Notice of Intent

Type of Action: Plug and Abandonment

Well Name: NORTH INDIAN BASIN

Well Number: 26

Current Wellbore

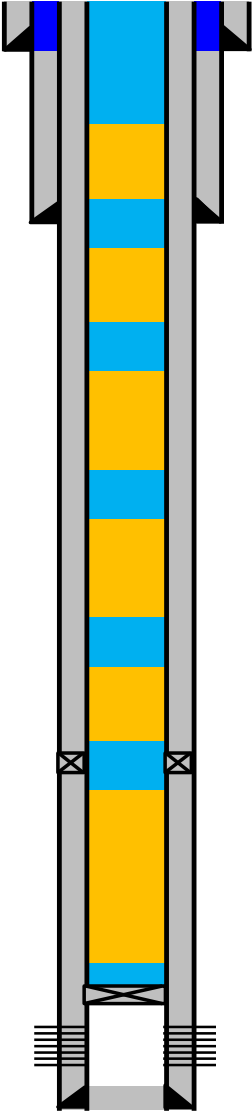
1. SET CIBP @ 7376'. SPOT ~~10~~ CLASS H CMT ON TOP 7376'-~~7326~~'. WOC AND TAG. ~~7376'-7252~~ 25 Sacks
2. RUN CBL 7300'-SURFACE.
3. SPOT ~~25~~ SX CLASS C CMT 6412'-~~6276~~'. WOC AND TAG. ~~27~~ Sacks 6412'-6248'
4. SPOT 25 SX CLASS C CMT ~~5850'-5714~~'. WOC AND TAG. ~~26~~ Sacks 5756'-5598'
5. SPOT 25 SX CLASS C CMT ~~3450'-3314~~'. WOC AND TAG. ~~25~~ Sacks 3051' to 2920'
6. SPOT 25 SX CLASS C CMT 2114'-1978'. WOC AND TAG.
7. SPOT 25 SX CLASS C CMT 1260'-1124'. WOC AND TAG.
8. SPOT 105 SX CLASS C CMT 547'-SURF. WOC AND VERIFY CMT AT SURF.

Sundry ID		2771577					
Plug Type	Top	Bottom	Length	Tag	Sacks	Cement Class	Notes
Surface Plug	0.00	100.00	100.00	Tag/Verify			
Fresh Water @ 350	296.50	400.00	103.50	If solid			
				If solid base no need to Tag (CIBP present and/or Mechanical Integrity Test), If Perf & Sqz then Tag, Leak Test all CIBP if no Open Perforations			
San Andres @ 497	442.03	547.00	104.97		89.00	C	Spot cement from 547' to surface. Verify at surface.

9.625 inch- Shoe Plug	1147.90	1260.00	112.10	Tag/Verify	25.00	C	Spot cement from 1260' to 1147'. WOC and Tag.
				If solid base no need to Tag (CIBP present and/or Mechanical Integrity Test), If Perf & Sqz then Tag, Leak Test all CIBP if no Open Perforations			
Glorieta @ 2060	1989.40	2110.00	120.60		25.00	C	Spot cement from 2110' to 1989'. WOC and Tag.
				If solid base no need to Tag (CIBP present and/or Mechanical Integrity Test), If Perf & Sqz then Tag, Leak Test all CIBP if no Open Perforations			
Bonesprings @ 3001	2920.99	3051.00	130.01		25.00	C	Spot cement from 3051' to 2920'. WOC and Tag.

If solid base no need to Tag (CIBP present and/or Mechanical Integrity Test), If Perf & Sqz then Tag, Leak Test all CIBP if no Open Perforations			
Wolfcamp @ 5706	5598.94	5756.00	157.06	ns	26.00	C	Spot cement from 5756' to 5598'. WOC and Tag.
DV tool plug	6248.38	6412.00	163.62	Tag/Verify	27.00	C	Spot cement from 6412' to 6248'. WOC and Tag.
				If solid base no need to Tag (CIBP present and/or Mechanical Integrity Test), If Perf & Sqz then Tag, Leak Test all CIBP if no Open Perforations			
CIBP Plug	7341.00	7376.00	35.00	ns	25.00	H	Set CIBP at 7376'. Spot 25 Sacks on top. (7376' to 7252') WOC and Tag.
Perforations Plug (If No CIBP)	7376.00	7830.00	454.00	Tag/Verify			
7 inch- Shoe Plug	7914.55	8095.00	180.45	Tag/Verify
